**Re: Amending the *Dane County Water Quality Plan* by Revising the Sewer Service Area Boundary and Environmental Corridors in the Oregon Urban Service Area (#2603 Village of Oregon – “Featherwood Trails”) (*actionable item*)**

Staff Analysis of Proposed Amendment to the  
*Dane County Water Quality Plan*  
**Revising the Sewer Service Area Boundary and Environmental  
Corridors in the Oregon Urban Service Area**  
***“Featherwood Trails”***

Figure 4. Conceptual grading and rear-yard swale (D'Onofrio, 2026)

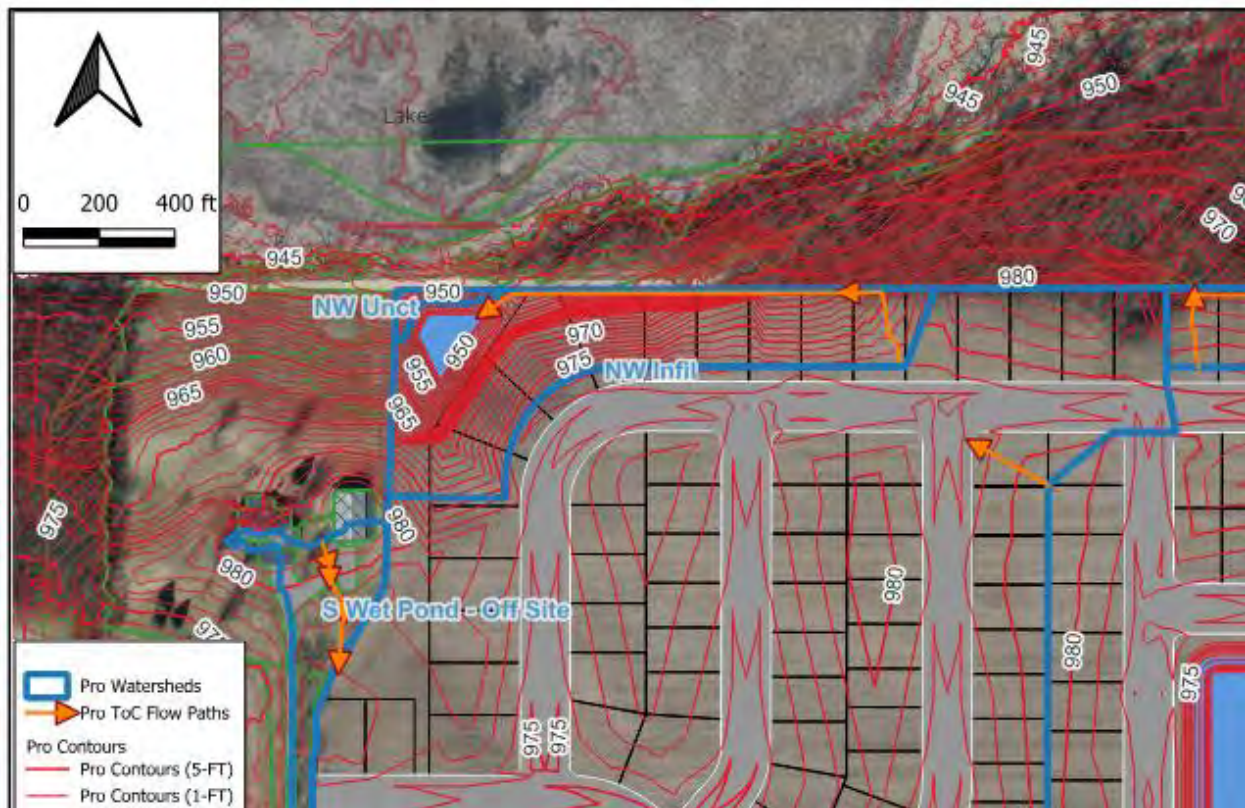
In addition to treating runoff from the proposed development within stormwater basins, the development team have also committed to use of native vegetation within proposed stormwater outlots and within a rear-yard swale that runs along the rear of the proposed lots bordering Lake Barney (see **Figure 4**). This native vegetation will provide enhanced filtering and volume reduction benefits not apparent in the reported performance results on the stormwater management system.

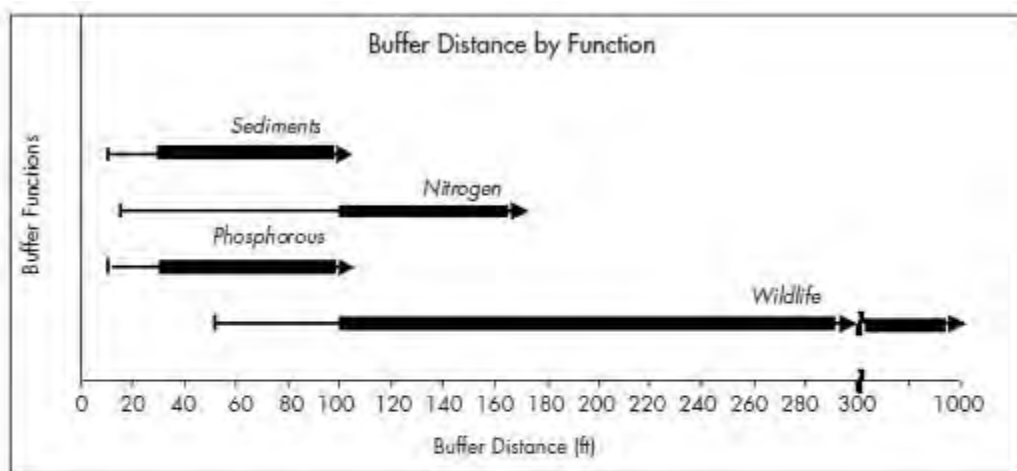
The proposed amendment area includes a total of approximately 12.7 acres of Environmental Corridor, per the concepts provided with the application (see **Map 12**). This will include the proposed stormwater management areas in accordance with the Policies and Criteria for Environmental Corridors ([link to document](#)<sup>3</sup>) adopted in the *Dane County Water Quality Plan*. A small amount of what is proposed as Environmental Corridor also coincides with mapped Voluntary Environmental Corridor, as described below. Estimated Environmental Corridors are

required to be included in Environmental Corridors when those areas are added to the urban service area. Estimated Environmental Corridors include natural resource features such as the 1% annual chance floodplain, waterbodies, streams and wetlands, plus their required vegetative buffers, riparian steep slopes, existing public lands, parks, and conservancy areas, and existing stormwater management facilities. These areas are mapped based on regionally available information, such as the Wisconsin Wetland Inventory data. The required 75 ft vegetated buffer for the wetland complex associated with Lake Barney is mapped just outside of the amendment area, though additional environmental corridor associated with the public stormwater outlots will provide additional buffering.

The purpose of a vegetated buffer is to provide water quality and wildlife protection/habitat functions. The Policies and Criteria for Environmental Corridors require a minimum 75 ft vegetated buffer to be designated as Environmental Corridors. A 75 ft vegetated buffer is effective for sediment or phosphorus control but could be less effective where nitrogen control or wildlife habitat functions are desired (see **Figure 5** below). Applying a greater buffer to the wetland complex associated with Lake Barney would better protect existing wetland and wildlife resources.
